UC HASTINGS
COLLEGE OF THE LAW
EST. 1878

ADDENDUM #2
UCH Garage Screen Door Panels
RFQ 78-0170

Additional Scope Picture #1 – Top Panels

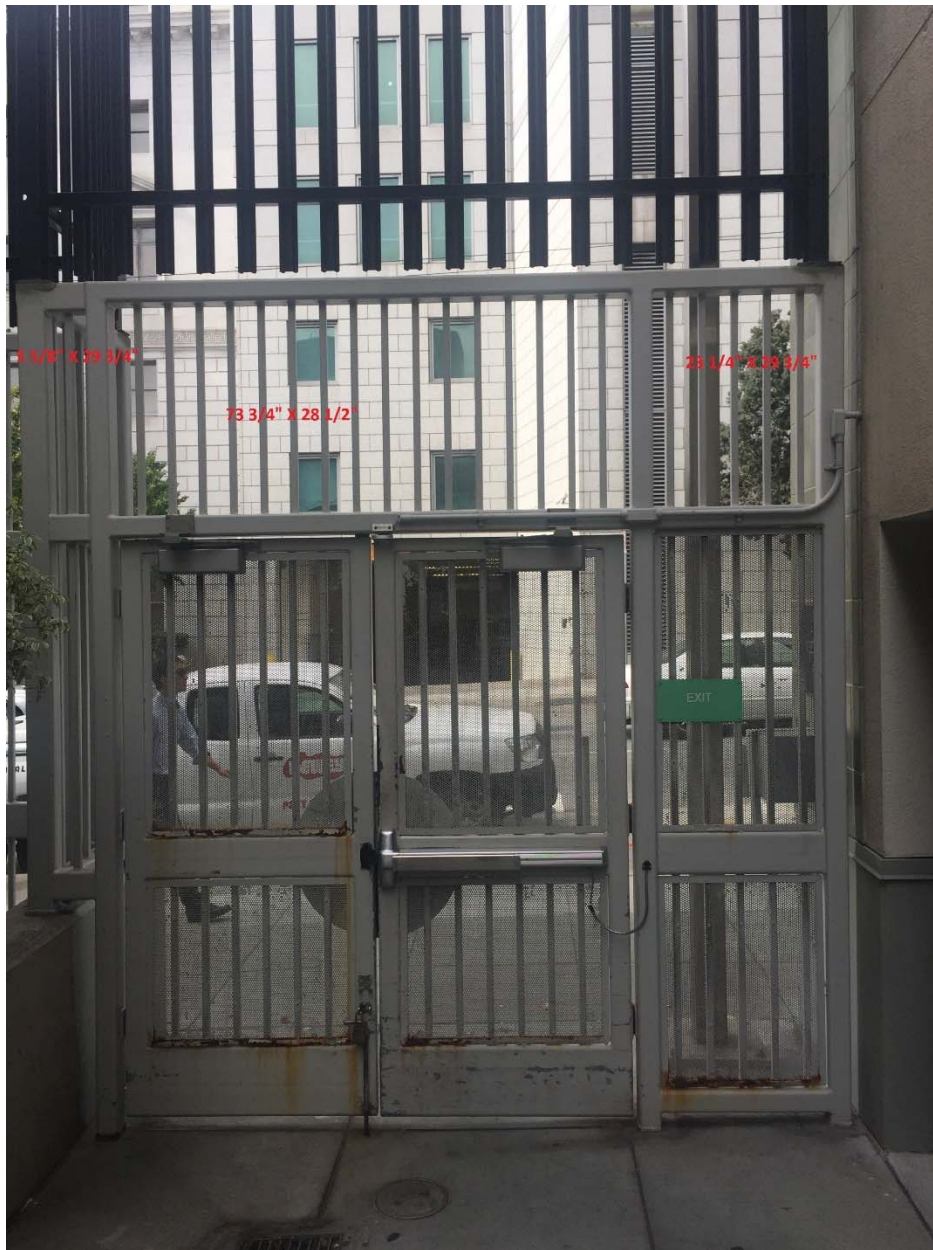
An additional seven (7) panels have been added to the original scope of work as outlined in the below two (2) pictures below and as detailed in the mandatory job walk.
